foundation investigation and design report

Highway 60 Underpass

FOUNDATION INVESTIGATION REPORT
For
Highway 11/60 - Interchange, Underpass
W.P. 148-86-00, Site: 42-190
Highway 11,
District #11, Huntsville

RE: Highway 11 & 60 Interchange Underpass
W.P. 148-86-02, Site 42-190
District 11

BORE HOLE LOCATIONS & SOIL STRATA

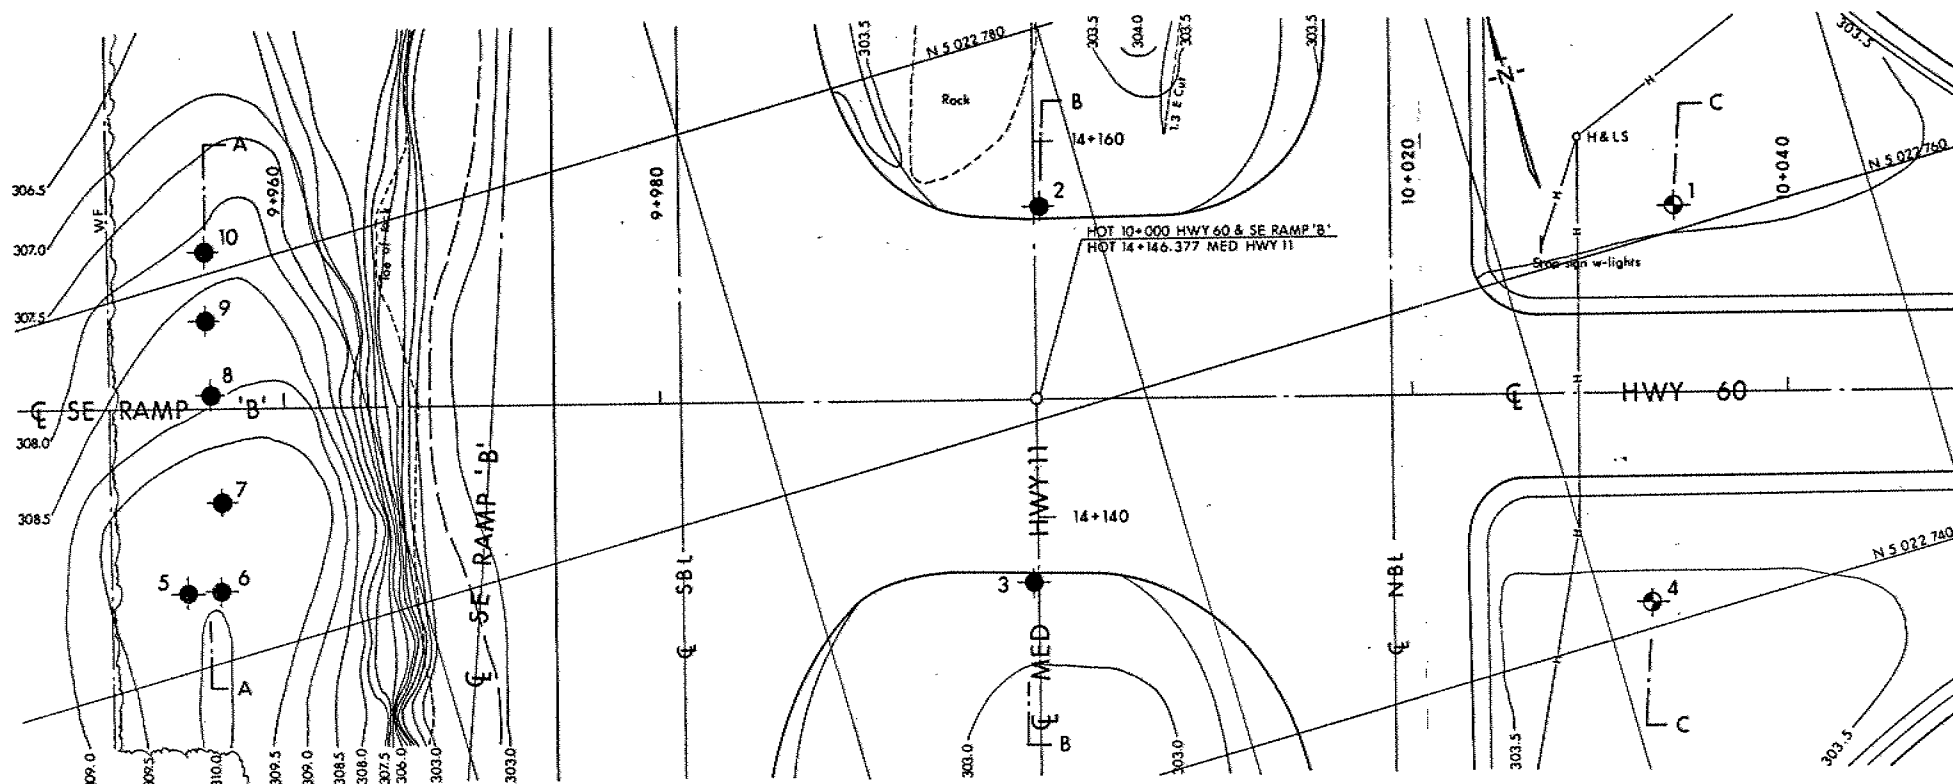
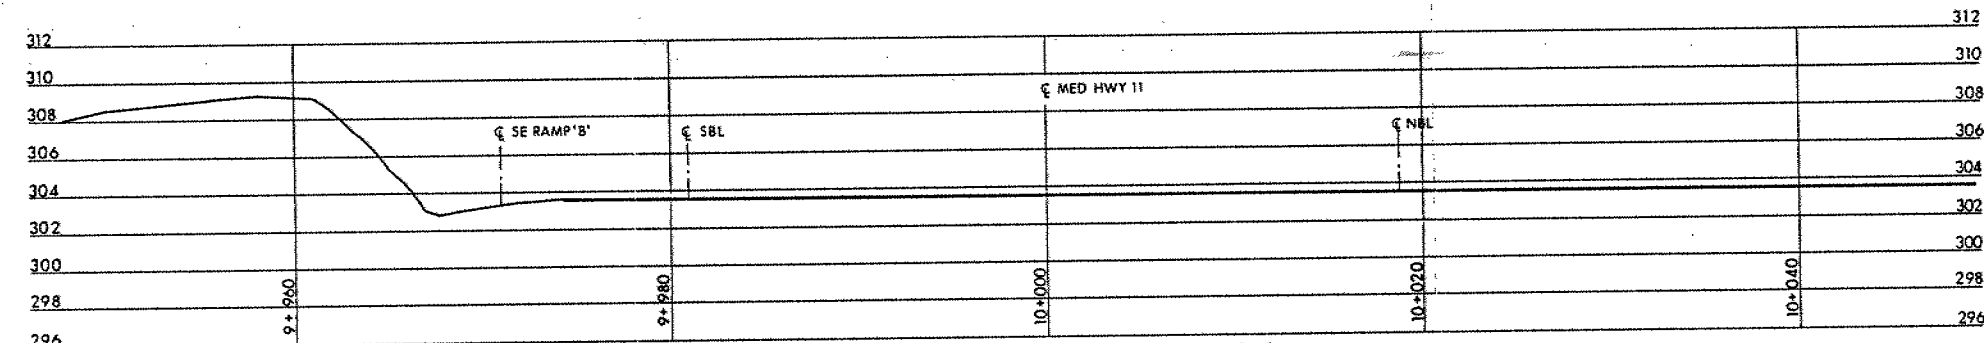
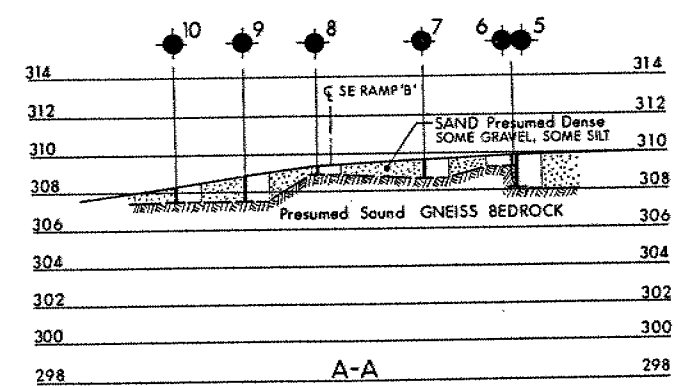
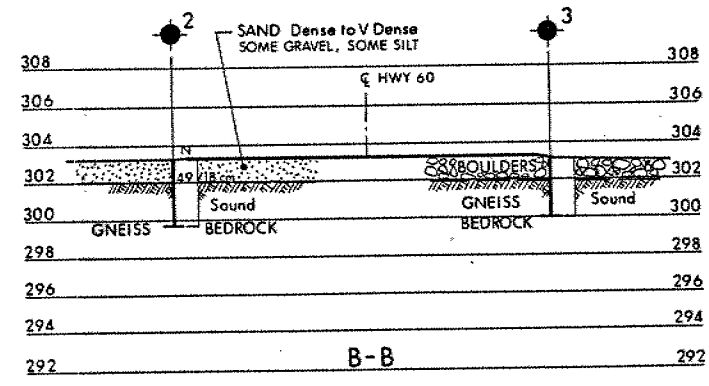
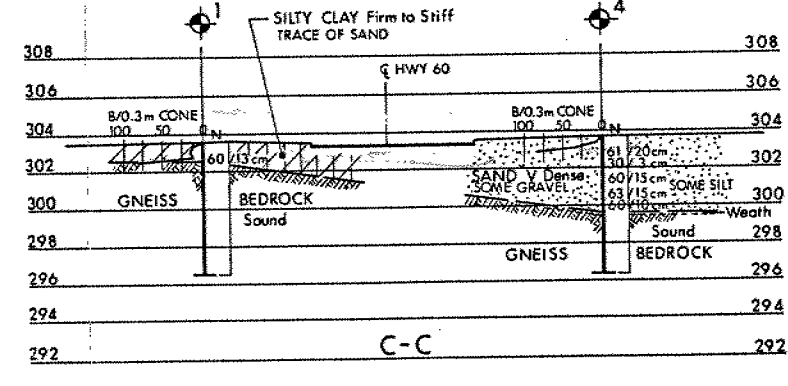
PARAGRAPHS #1, #2 AND #3 OF THE 'GEOTECHNICAL INFORMATION' (SEE ATTACHMENT 'A') ARE DEALING WITH FOUNDATION RELATED PROBLEMS FOR BOTH ABUTMENTS AND FOR THE CENTER PIER. THE ACTUAL BEDDED LINE, THE CONSTRUCTION REPORT CLAIMS, FOR ALL THREE FOOTINGS WERE LOWER THAN INDICATED ON THE FOUNDATION DRAWING (DWG. #2) AND ON THE RECORD OF BOREHOLE SHEETS. THE RESULT OF THE LOWER BEDROCK LINE REQUIRED ADDITIONAL OVERBURDEN EXCAVATION ADDITIONAL QUANTITIES OF GRANULAR 'A' AND CONCRETE AND ALSO THE COMPLETE RE-DESIGNMENT OF THE WEST ABUTMENT FOR GRAND TOTAL OF

- c.) AT THE WEST ABUTMENT, SIX BOREHOLES WERE DRILLED (UP TO 1.8m DEEP) BUT NOT ONE SINGLE BOREHOLE PENETRATED THE BEDROCK, THEREFORE THE QUALITY OF THE ROCK COULD NOT BE ASSESSED.

- d.) DURING THE OVERBURDEN ^{EXCAVATION} FOR THE WEST ABUTMENT IT HAS BECOME EVIDENT THAT THE BEDROCK IS SHATTERED TO A GREAT EXTENT. MY SITE VISIT (1989 10 11) CONFIRMED THE SITUATION AND NEW RECOMMENDATIONS WERE PROVIDED TO THE AREA CONSTRUCTION ENGINEER (T. FLETCHER) BY THE UNDERSIGNED (SEE ATTACHMENT 'D').

- e.) AT THE EAST ABUTMENT THE BOREHOLES (#1 AND #4) WERE LOCATED SOME 6-7m WEST OF THE FOOTING LOCATION, WHICH MAY EXPLAINS THE DISCREPANCY OF THE BEDROCK SURFACE ELEVATION.

- f.) THE LOWER BEDROCK LEVEL AT THE CENTER PIER MAY BE RESULT OF THE OVEREXCAVATION BY THE CONTRACTOR. HOWEVER, I CAN NOT PROVE THIS FACTOR.
- g.) IT IS MY OPINION, THAT SOME ^{PORTION} OF ^{THE} ADDITIONAL CONSTRUCTION COST MAY HAVE BEEN INCLUDED

1. Remove rock to El. 306
2. Should the bedrock be fractured at this level, extend the removal for 1 m more and bring it up with mass concrete.
3. The footing should be redesigned using factored bearing capacity at U.L.S. of 7500 kPa.

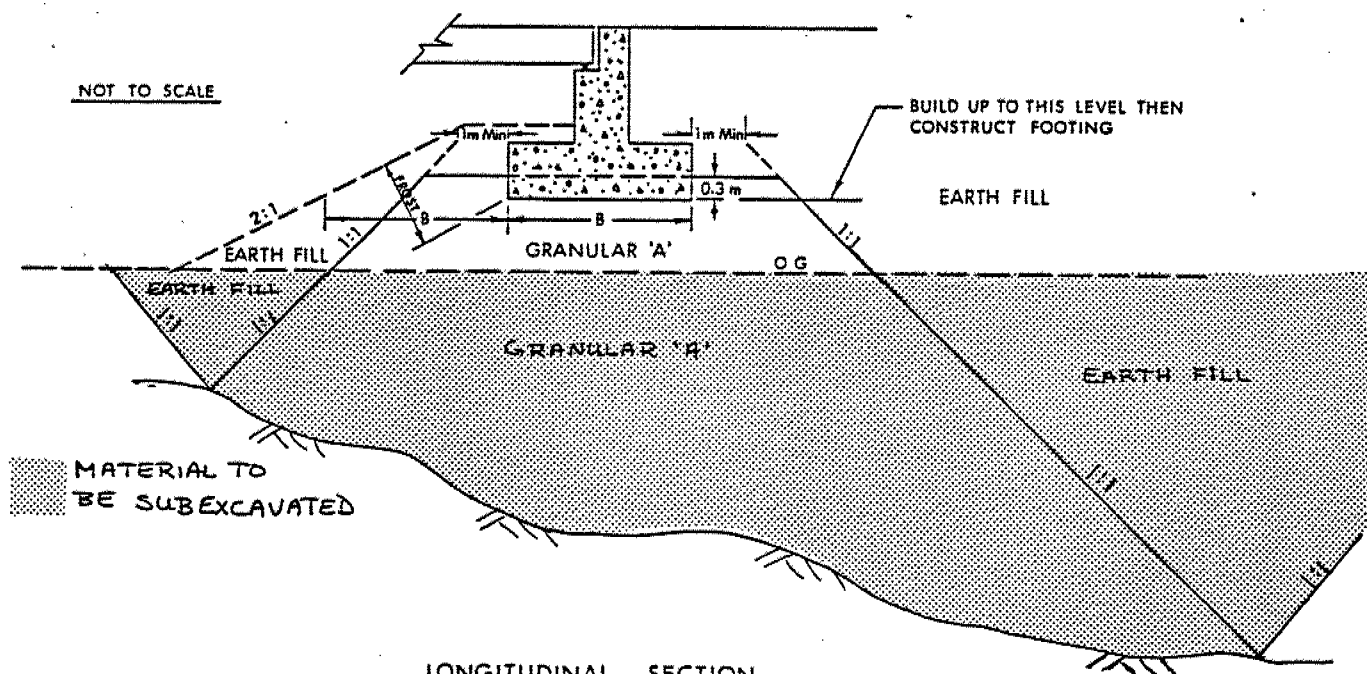
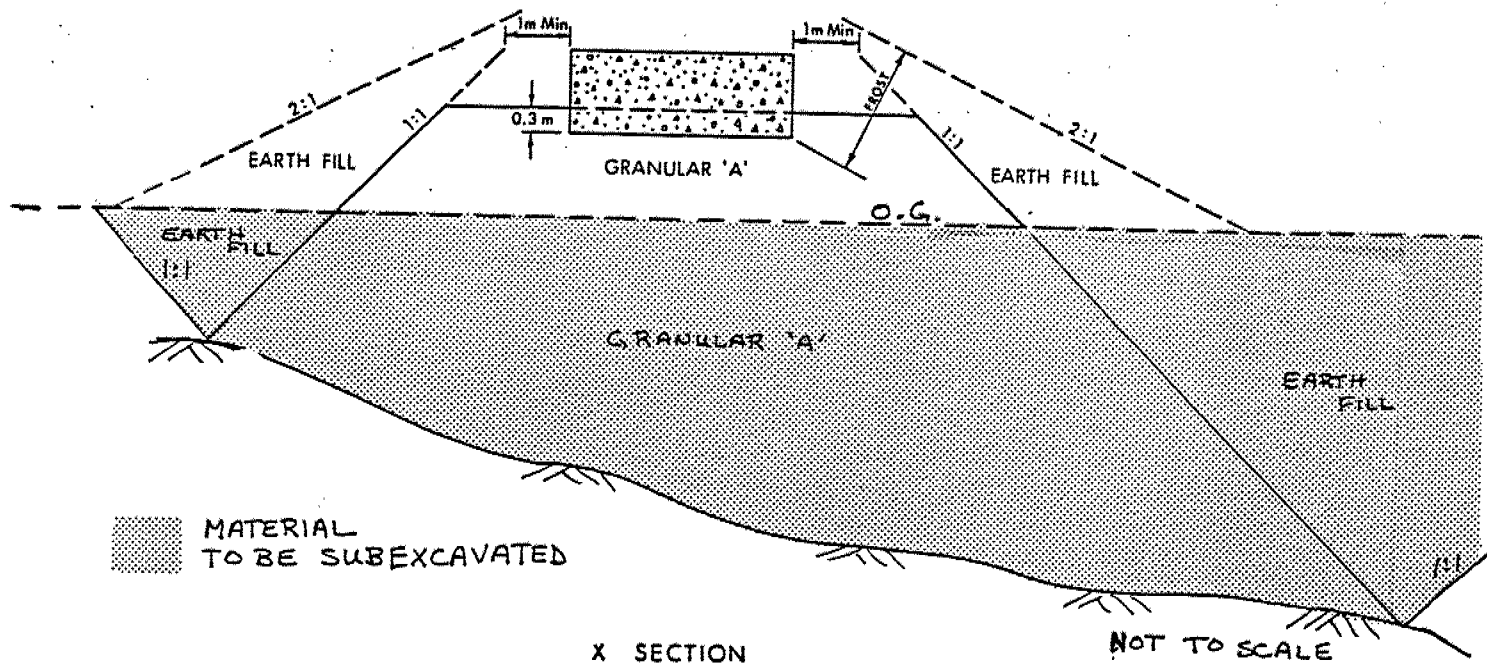
The following is in reply to our discussion on 88 01 26 with D. Sproule regarding an additional alternative for supporting the east abutment on a spread footing placed on a granular pad. The following additional recommendations are being made with regards to this alternative.

The east abutment may be supported on spread footings placed on well compacted Granular 'A'. A detailed construction scheme is outlined in Figure 1 attached. A safe design load of 340 kPa may be used for design purposes. For the purposes of the O.H.B.D.C. the following values are recommended:

- 1- REMOVE TOPSOIL &/OR SOFT SUBSOIL UNDER AREA OF COMPACTED GRANULAR 'A' & EARTH FILL.
- 2- PLACE GRANULAR 'A' & EARTH FILL TO BOTTOM OF FOOTING LEVEL, COMPACTED ACCORDING TO CURRENT M T C STANDARDS.
- 3- CONSTRUCT CONCRETE FOOTING.
- 4- PLACE REMAINDER OF GRANULAR 'A' & EARTH FILL AS REQUIRED.
